PowerSpan II™ Device Errata and Design Notes

80A1010_ER001_13

November 4, 2009

Figure 1: Logic Required to Delay Deasserting PO_RST_ to PowerSpan II

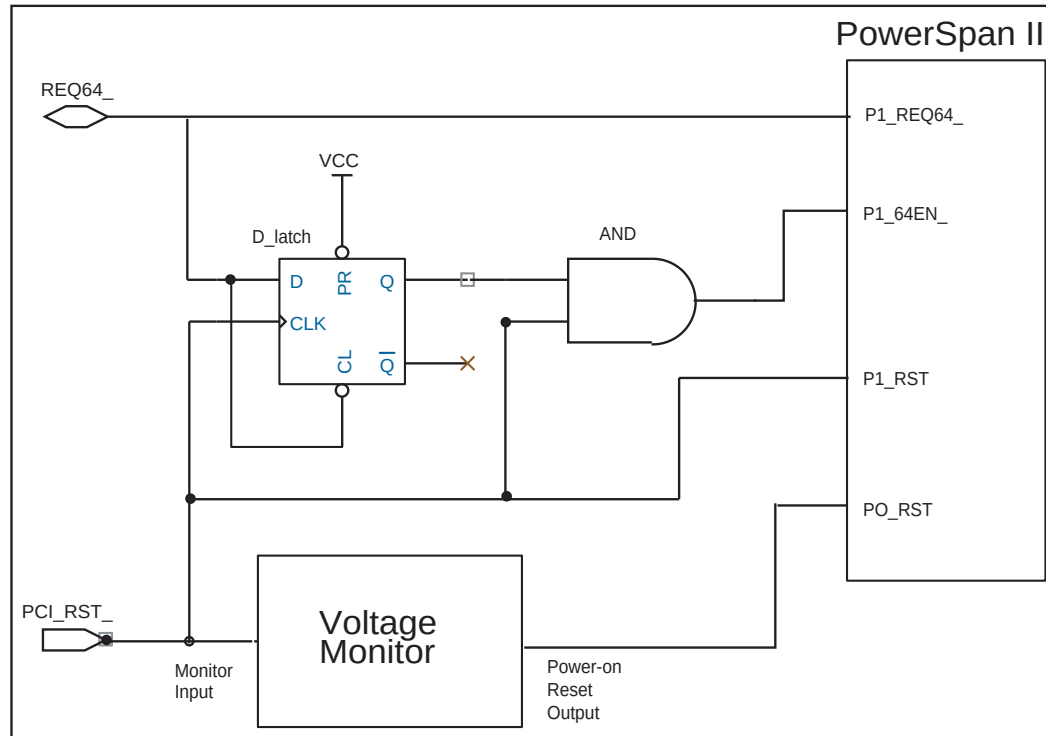
The proposed work-around to this situation is to delay deasserting PO_RST_ to PowerSpan II until the host deasserts the PCI_RST_ signal. Since the PCI_CLK is an output from the system controller along with PCI_RST_, the negation of PCI_RST_ implies the PCI_CLK is stable. The local voltage monitor uses PCI_RST_ to make sure that the PCI_CLK is stable before the deassertion of PO_RST_. A possible implementation of this circuit is shown in [Figure 1](#).

By generating PO_RST_ off of PCI_RST_, there is a chance that the PowerSpan II will be unable to latch the state of the REQ64_ signal on deassertion of PCI_RST_. Therefore, an external D-Latch is used to capture the state of REQ64_ to determine the width of the bus (see [Figure 1](#)). The purpose of the asynchronous clear on D-latch is to prevent potential bus contention on the REQ64_ signal which is driven by PowerSpan II on the deassertion of P1_RST_ in a 32-bit system. The P1_64EN_ signal, which is originally used for CompactPCI Hot Swap applications, is used here to tell the PowerSpan II if this is a 32 or 64-bit application. The AND gate is AND-ing the output of D-latch with PCI_RST_ to ensure the P1_64EN_ is low when the D-latch power-up with uncertain output.

Figure 1 shows the logic required to delay deasserting PO_RST_ to PowerSpan II until the host deasserts the PCI_RST_ signal.

If the external glue logic shown in Figure 1 is implemented by a CPLD, make sure the CPLD output and Flip-flop state are not affected by any reset.

This work-around only applies to designs where PowerSpan II is in a PCI adapter card and is configured for a non-Hot Swap environment. Normally in this scenario, the PCI bus width is indicated by P1_REQ64_ signal (P1_64EN_ is pulled high). For designs where PowerSpan II is in a PCI host card or it is configured for a Hot Swap environment, the circuit shown in Figure 1 must not be used.
